# UNITED STATES PATENT AND TRADEMARK OFFICE

APPLICATION NO.	FILING DATE	FIRST NAMED INVENTOR	ATTORNEY DOCKET NO.	CONFIRMATION NO.
10/803,811	03/18/2004	Takashi Sasabayashi	2003054A125US	5595
24978	7590	06/21/2006	EXAMINER	
GREER, BURNS & CRAIN 300 S WACKER DR 25TH FLOOR CHICAGO, IL 60606			NGUYEN, THINH T	
			ART UNIT	PAPER NUMBER
			2818

<b>Office Action Summary</b>	<b>Application No.</b>	<b>Applicant(s)</b>	
	10/803,811	SASABAYASHI ET AL.	
	<b>Examiner</b>	<b>Art Unit</b>	
	Thinh T. Nguyen	2818

### **DETAILED OFFICE ACTION**

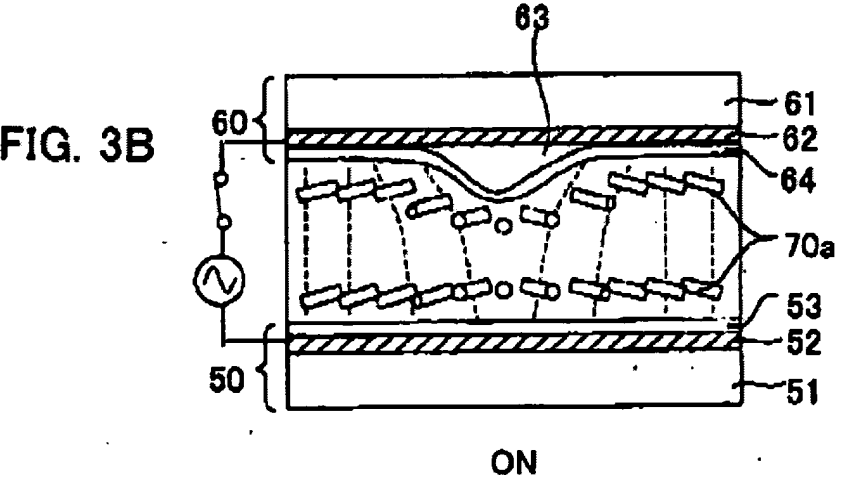
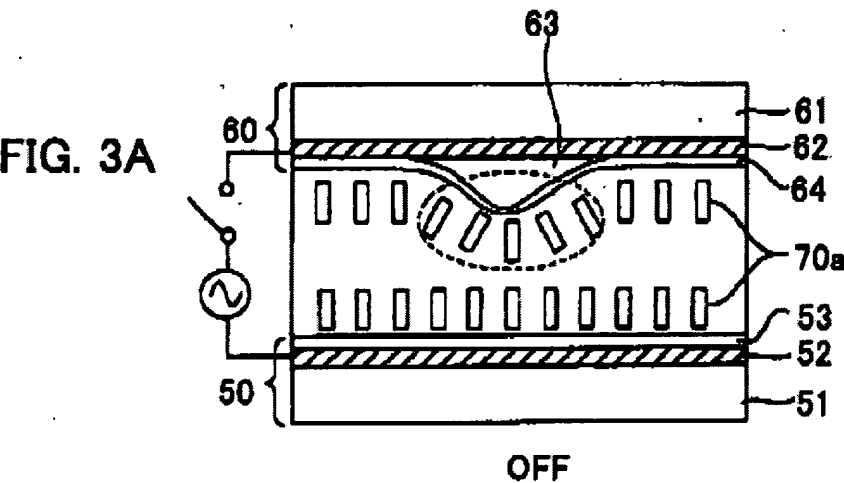
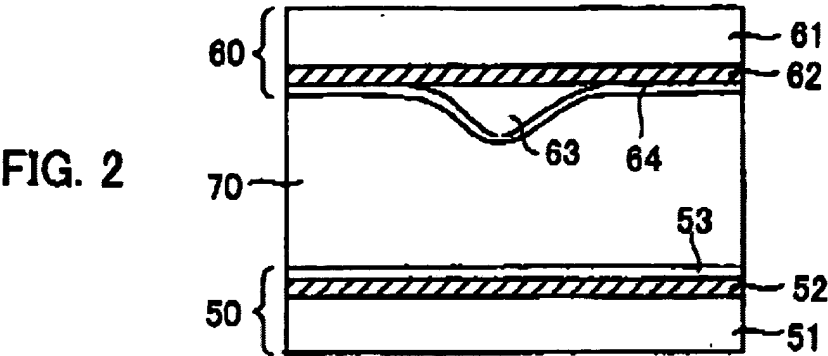
4. The Drawings are objected to because Fig. 1,2,3A,3B,4,5 are not designated by a legend such as “ prior art “. The legend is. necessary in order to clarify what applicant ‘s invention is (see MPEP paragraph 608.02).

7. Claim 14,15,16 are rejected under 35 U.S.C. 102(a) as being anticipated by Applicant Admitted Prior Art or Background art ( fig 3A, 3B, page 7 line 2-19 in the BACKGROUND section ) ( fig 2, fig 3A, 3B, page 7 line 2-19 in the BACKGROUND section )

The AAPA (fig 2, fig 3A, 3B, page 7 line 2-19 in the BACKGROUND section ) discloses a liquid crystal display apparatus comprising a first and second substrates ( fig 3A reference numeral 61,51) which are disposed facing each other, a liquid crystal ( fig 3A layer 70) sealed between said first and second substrates, a first electrode ( fig 3A, layer 52) formed on the liquid crystal side surface of the first substrate, a second electrode ( fig 3A layer 62) formed on the liquid crystal side surface of the second substrate, alignment control layers ( fig 3A layer 53,64) which cover the surfaces of said first and second electrodes and control the alignment direction of the liquid crystal molecules when no voltage is applied to be roughly vertical from the substrate face ( fig 3A) , and bumps which are formed on at least one surface of said first and second substrates and determine the tilting directions of the liquid crystal molecules when voltage is applied, ( fig 3B) wherein both of said alignment control layers and said bumps are formed by polymerizing a polymerizable compound which is added to said liquid crystal, and the alignment direction of the liquid crystal molecules near the bumps when no voltage is applied ( fig 3A ) is roughly vertical from the substrate face.

Noted that the bump and alignment control layer 64 are made of polyimide ( Background art page 6 lines 26-27 ) and polyimide is inherently a polymer compound. Also noted that the limitation —“ **formed by polymerizing** “—**is a product by process as set forth in the previous paragraph and is considered non-limitation..**

The AAPA ( fig 2,fig 3A, page 6 lines 10-18) discloses a liquid crystal display apparatus wherein both of the first and second substrates and both of the first and second electrodes are transparent.

The AAPA ( fig 2,fig 3A, page 6 lines 10-18) discloses a liquid crystal display apparatus wherein at least part of said bumps contacts said first and second substrates.

The AAPA (fig 2, fig 3A, 3B, page 7 line 2-19 in the BACKGROUND section ) discloses a liquid crystal display apparatus comprising a first and second substrates which are disposed facing each other, ( fig 3A reference 51,61 ) a liquid crystal sealed between said first and second substrates ( fig 2 reference 70 ) , tilt control sections which are disposed on at least one of said first and second substrates and determine the tilting directions of the liquid crystal molecules when voltage is applied, and alignment control layers ( layer 64,53) which are formed on the liquid crystal side faces of the first and second substrates and control the alignment direction of the liquid crystal molecules when no voltage is applied to be roughly vertical from the substrate face, wherein said alignment control layers are formed by polymerizing a polymerizable compound which is added to said liquid crystal.

The AAPA (fig 2, fig 3A, 3B,) discloses a liquid crystal display apparatus wherein the tilt control sections are bumps or dents installed on at least one of the first and second substrates.

Claims 25-26 have the limitation of product by process and are considered non-limitations as set forth in paragraph 6 of the Office Action therefore the AAPA ( fig 2,fig 3A,fig 3B ) correctly anticipated claims 25,26.
